RE: Application of Homeland/Verizon Wireless ("Applicants" for Special Permit,
Site Plan and Steep Slope Permits and Application for Variances ("Applications")
180 So. Bedford Road, Mt Kisco NY (P/O Tax ID # 80.44-1-1)

RE: Application of Homeland/Verizon for Special Permit,
Site Plan and Steep Slope Permits and Application for Variances
180 So. Bedford Road, Mt. Kisco NY (P/O Tax ID # 80.44-1-1)

4 UNDERGROUND INFILTRATION SYSTEM

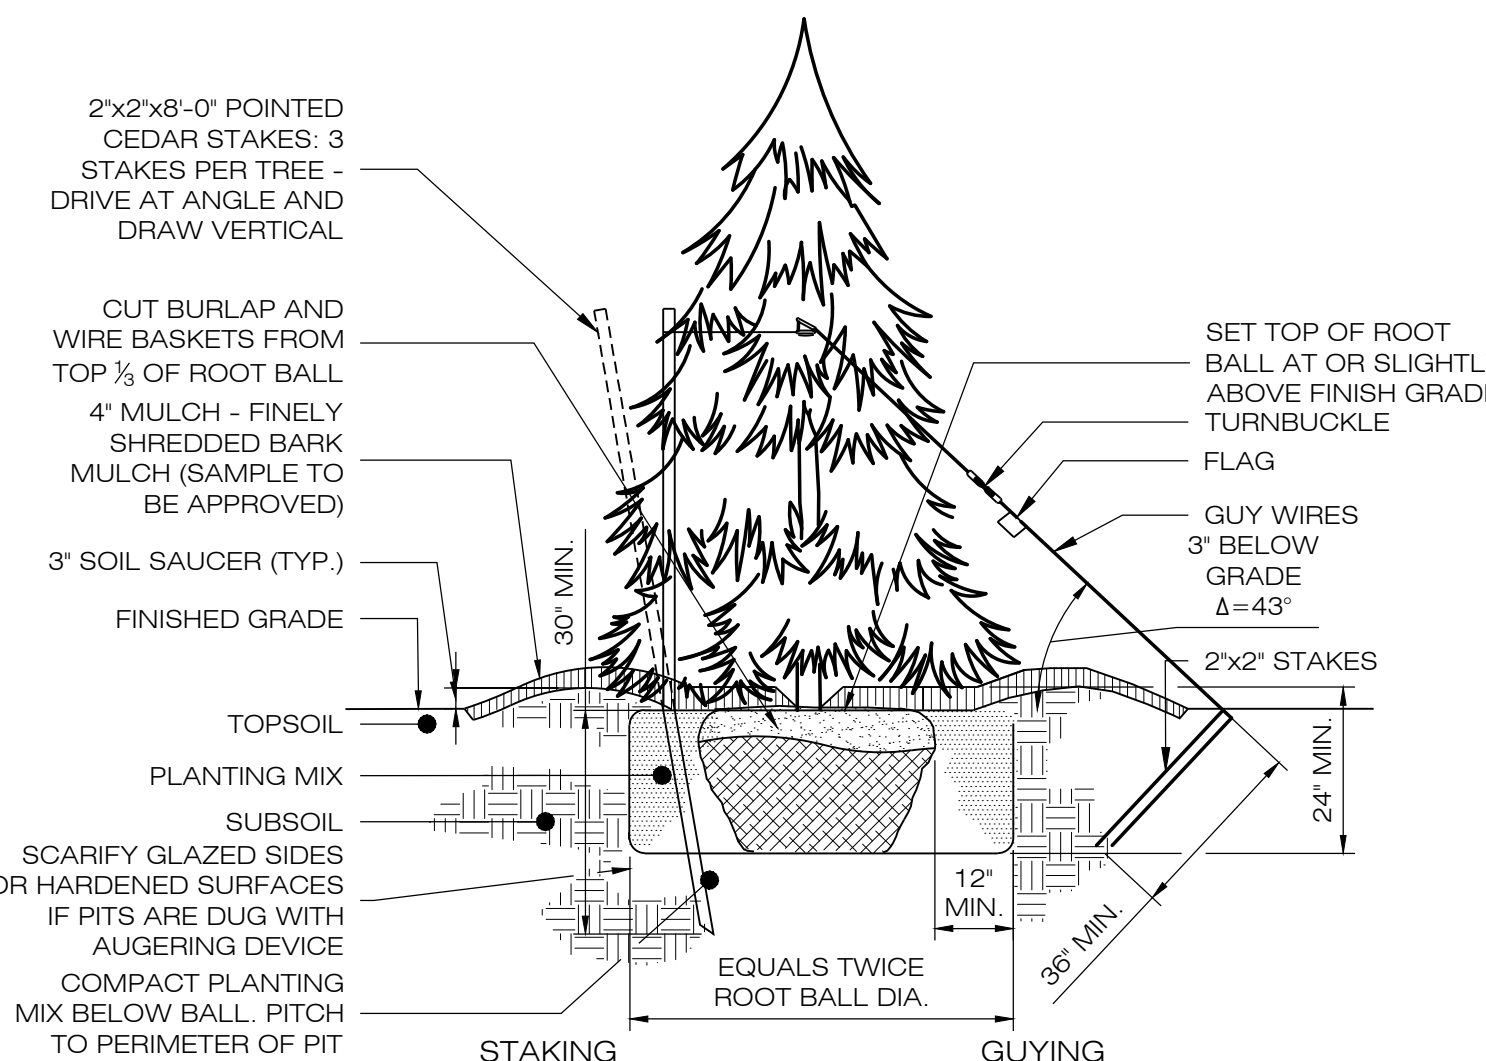
- Infiltration practices should only be located on slopes less than 15%, it appears that there are slopes exceeding this in the footprint.
The infiltration design at the proposed compound has been revised. An underground infiltration system has been placed on existing slopes less than 15% (see Drawing SP-4 and Detail 4 on Drawing C-5).

- Infiltration must occur into the existing soil strata, not what would appear to be a layer of fill beneath the gravel.
The infiltration design at the proposed compound has been revised. An underground infiltration system has been placed below the proposed compound on existing soils. A 6" perforated pipe will capture the runoff collected within the gravel compound and will flow into the infiltration system with (16) Infiltration units. (see Drawing SP-4 and Detail 4 on Drawing C-5).

- There is a concern that seepage will occur at the base of the filled slopes downhill of the compound area. Infiltration should occur at a lower elevation within the proposed compound cross section.
The infiltration design at the proposed compound has been revised to be below the proposed compound. (see Drawing SP-4 and Detail 4 on Drawing C-5).

2 FLOW SPLITTER FS 1.6 DETAIL

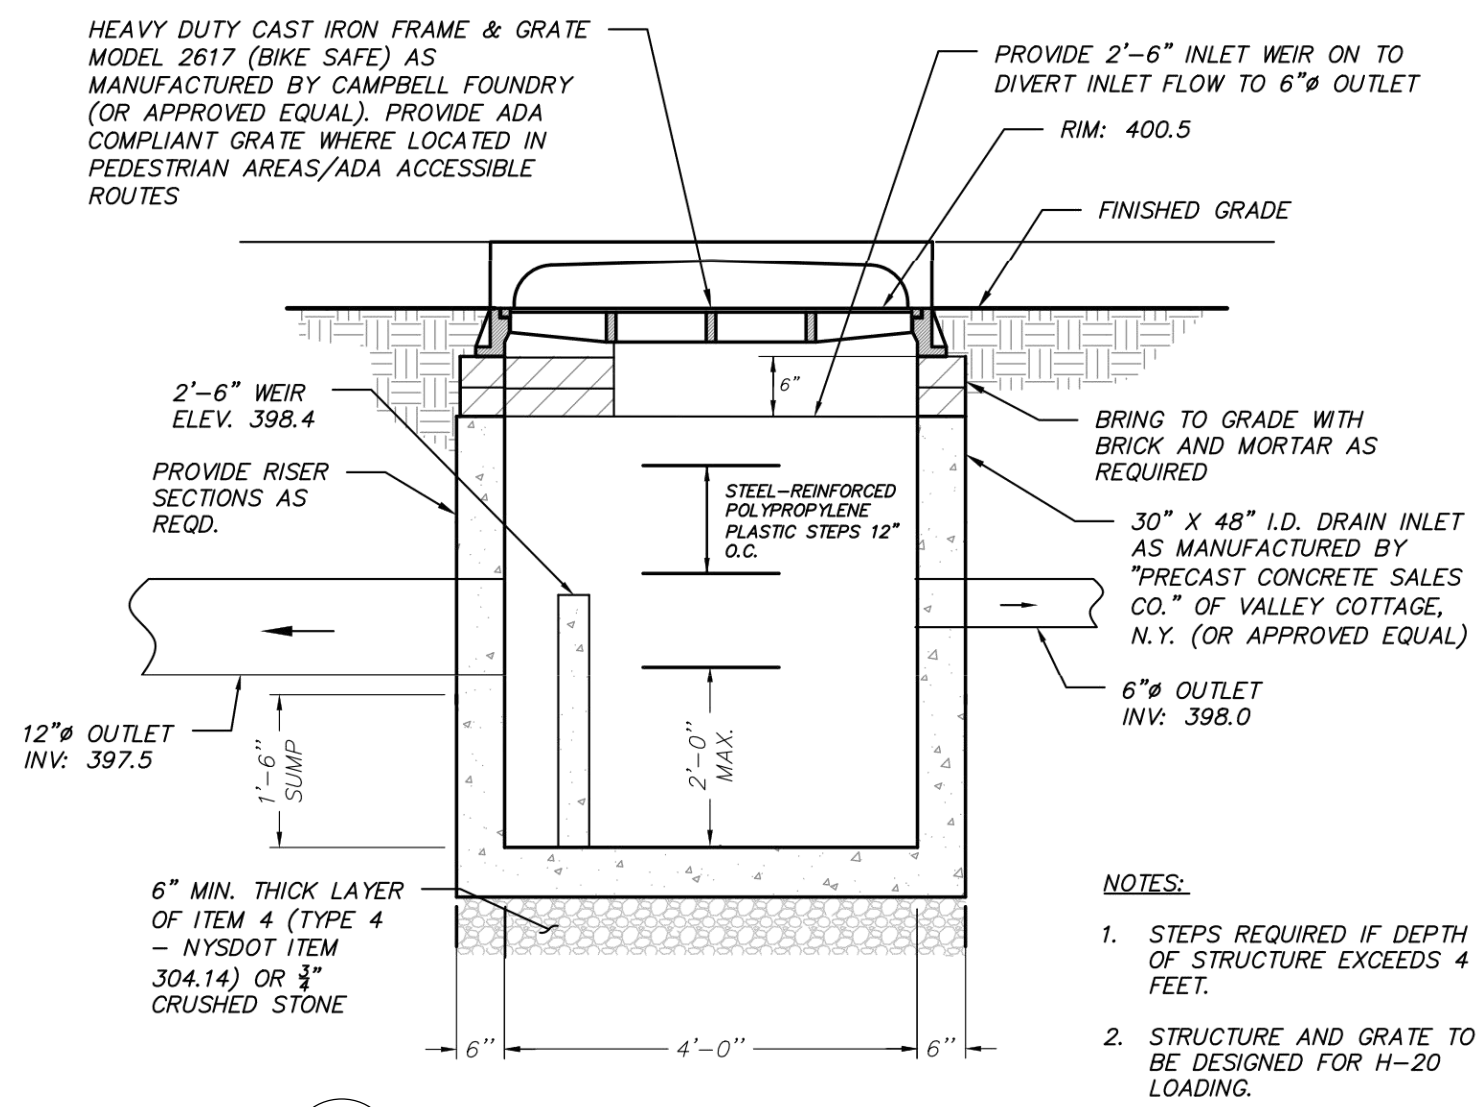
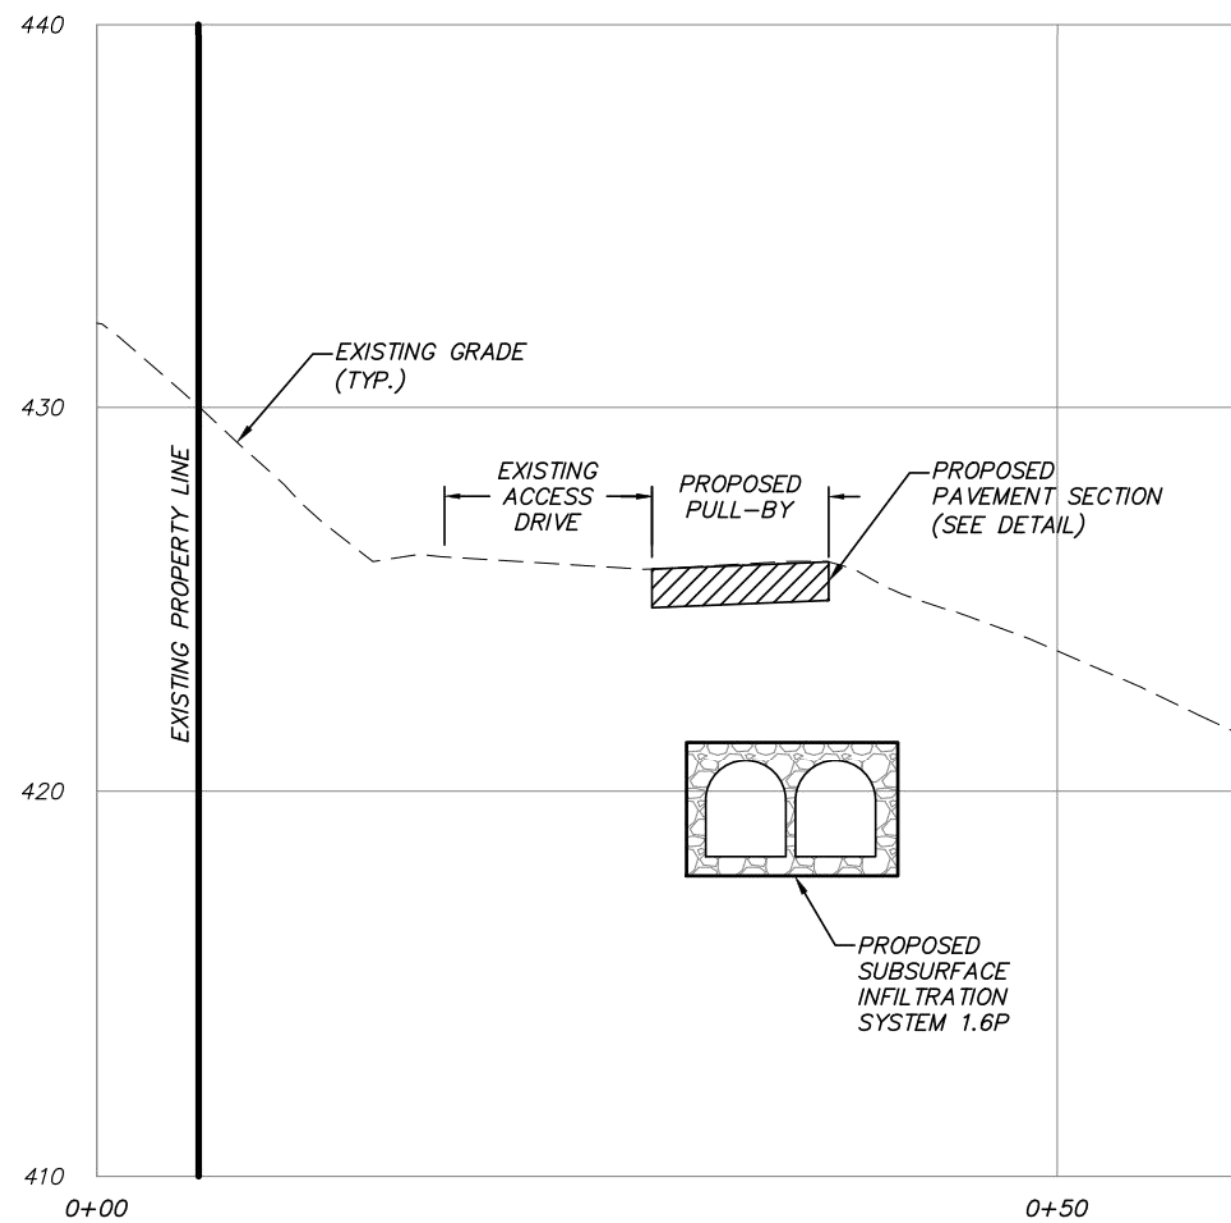
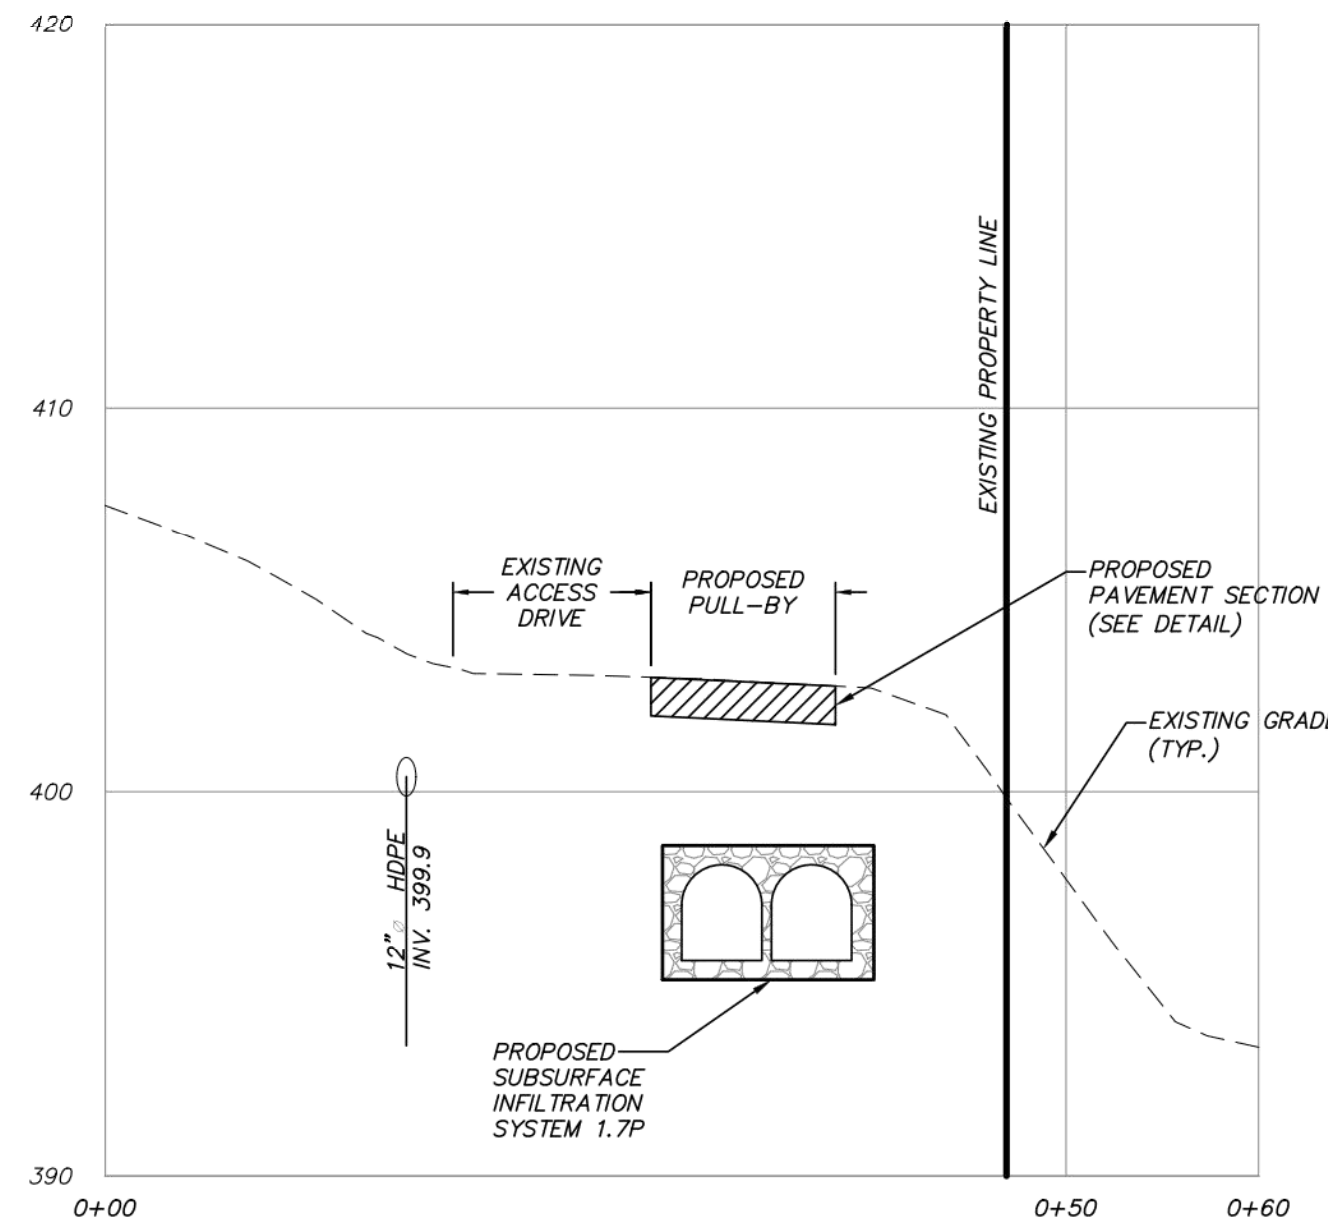
9. Proposed "type c" catch basins along the access drive are noted as "flow splitter" structures in the SWPPP and on the solar panel application; this needs to be coordinated and details provided demonstrating how these will function effectively to separate flows with water entering from the above grate.
Details for the Flow Splitter structures have been added to Drawing C-8.
